233124 PSC Modifications
Imperial Oil Resources Limited

DOCUMENT TITLE: RFI – NPS 26 FROTH BEND SPOOL

Subject: NPS 26 Froth Bend Spool

SP-K3493

KEARL PLANT 1
24"/26" FROTH RECYCLE LINE PSC-3015
PSC AVAILABILITY CWM SPOOLS

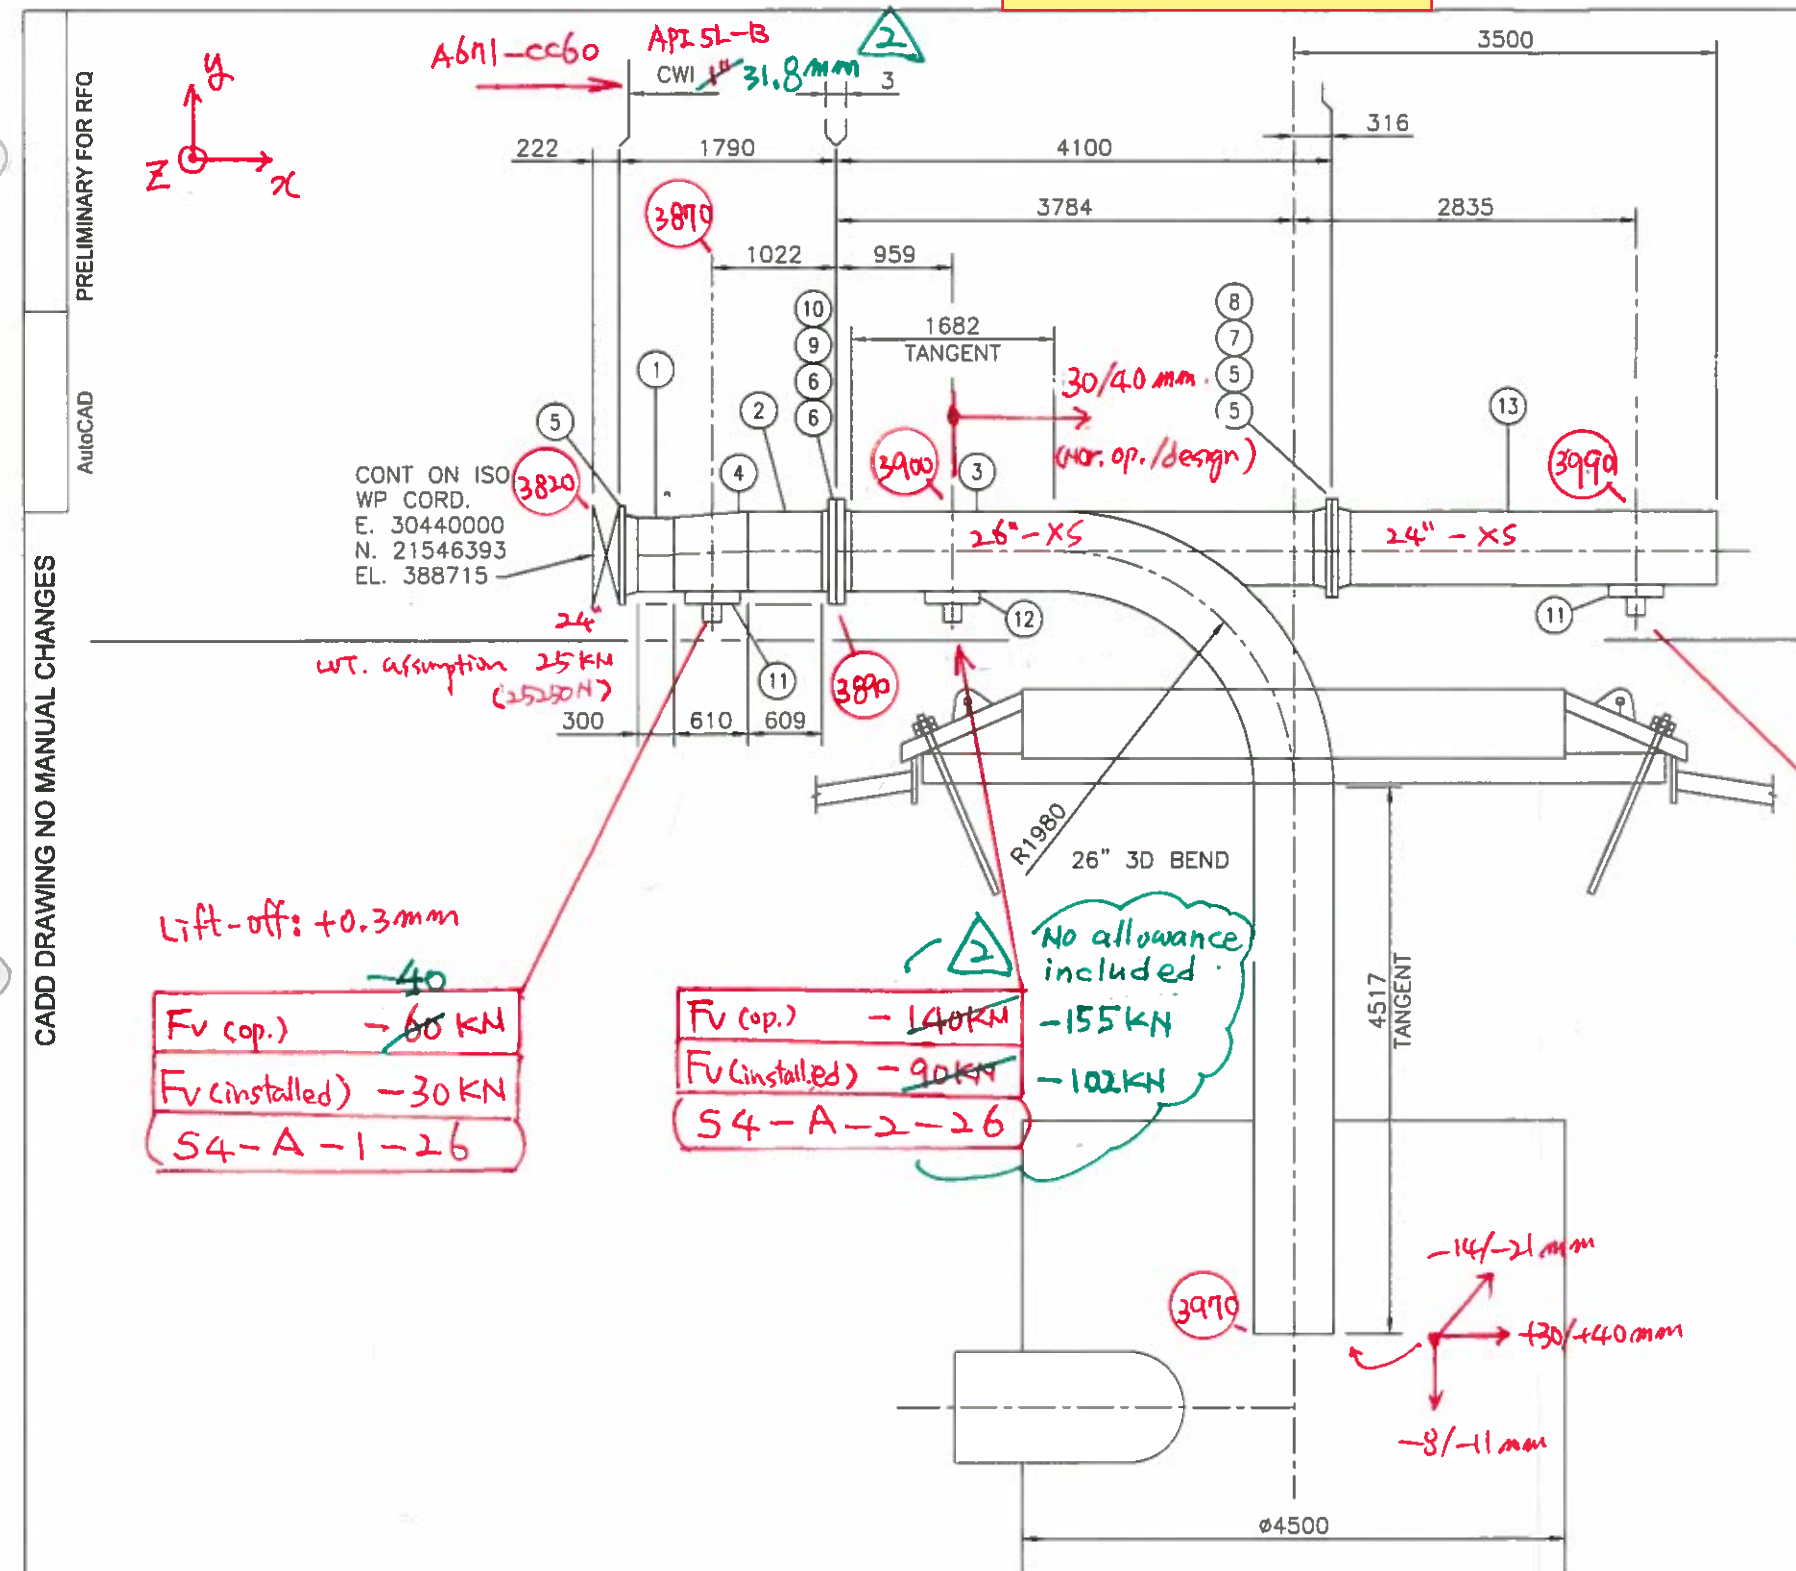
Narjeet,
Response is attached. Please note there is a slight increase in the loads at support 3900.
Regards
Vijay

$F_v(\text{cop.}) - 140 \text{ kN} \rightarrow -155 \text{ kN}$
 $F_v(\text{installed}) - 90 \text{ kN} \rightarrow -102 \text{ kN}$
 54-A-2-26
